Inspection Report for North Sturbridge Road Solar Facility

NPDES ID No.: MAR10031G

Inspection Date: 5/4/2022

**FIGURE 1:
SWPPP
INSPECTION
SKETCH
5/4/2022**

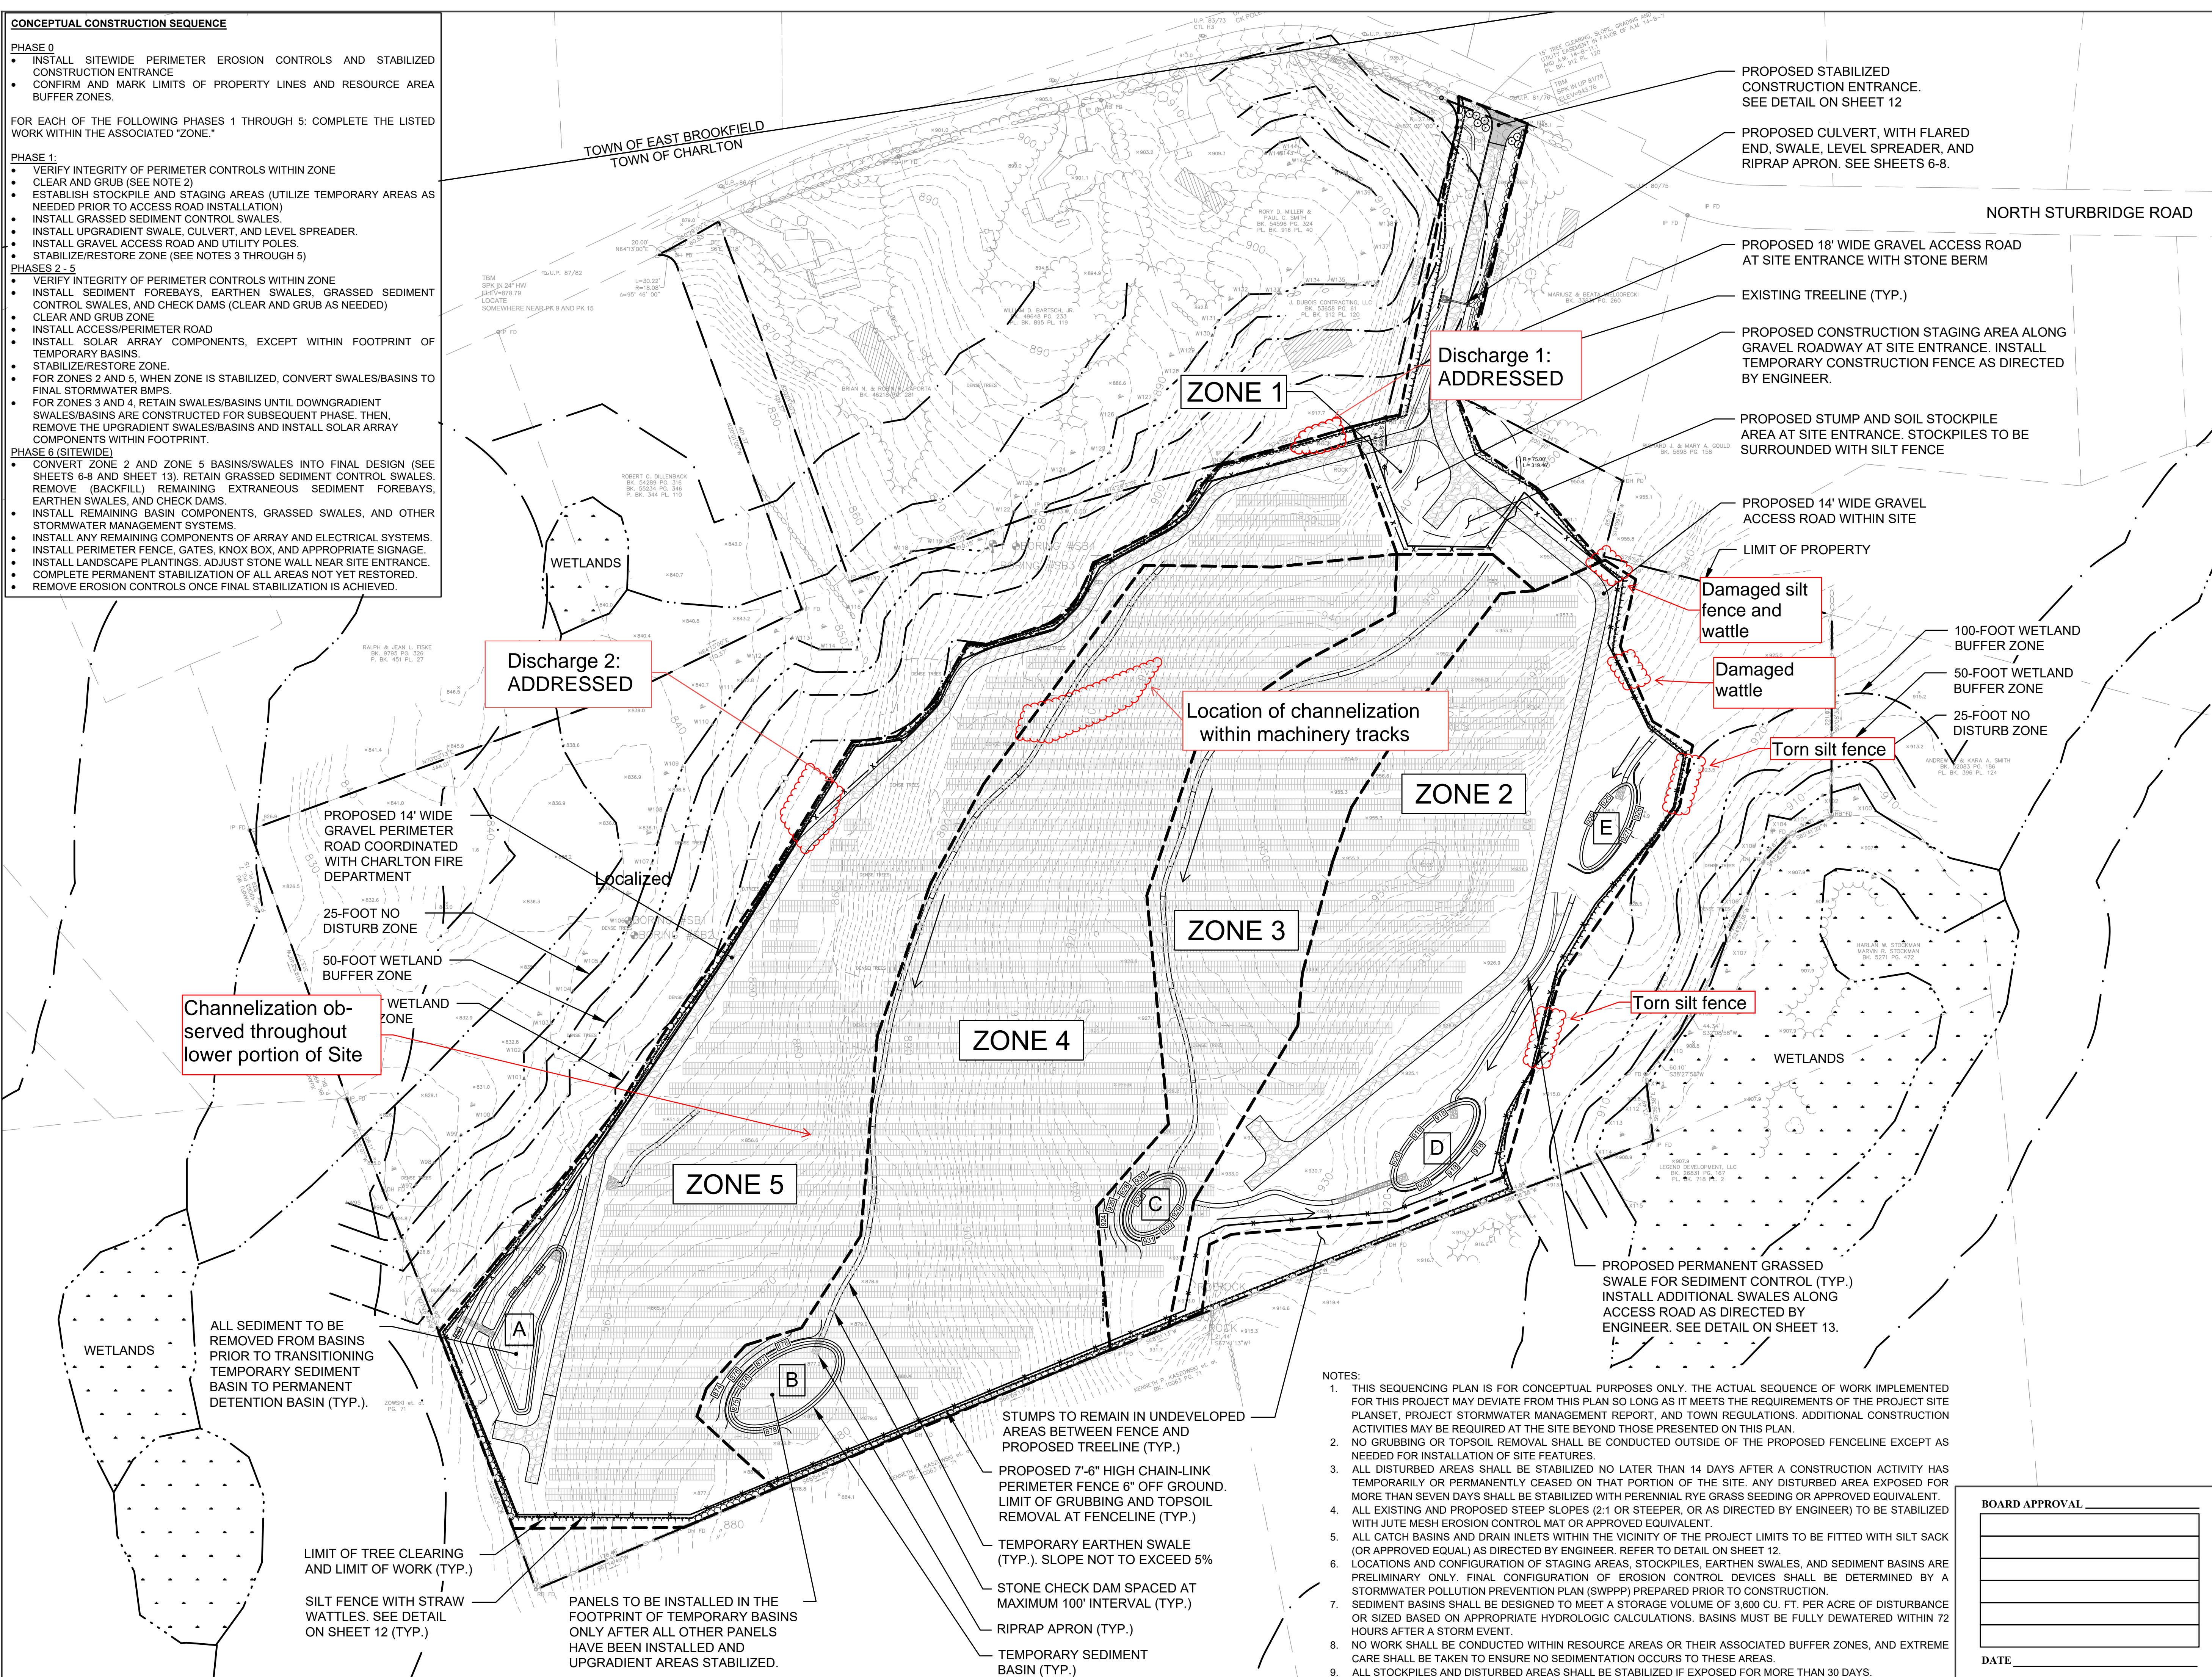
2. Informal access road along northern portion of the Site	Straw mulch or hydroseed	<input type="checkbox"/> Yes [Enter date] <input checked="" type="checkbox"/> No	Erosion channels are beginning to form within upgradient portions of the informal access road (Figure 1). The contractor indicated that stabilization by smoothing out soils and seeding or spreading mulch would occur on 7/30/2021. Stabilization of this area has not been initiated. After inspection of the area on 8/24/2021, it was determined that

Damaged silt fence and wattle

Damaged wattle

Torn silt fence

Location of channelization within machinery tracks

Channelization observed throughout lower portion of Site
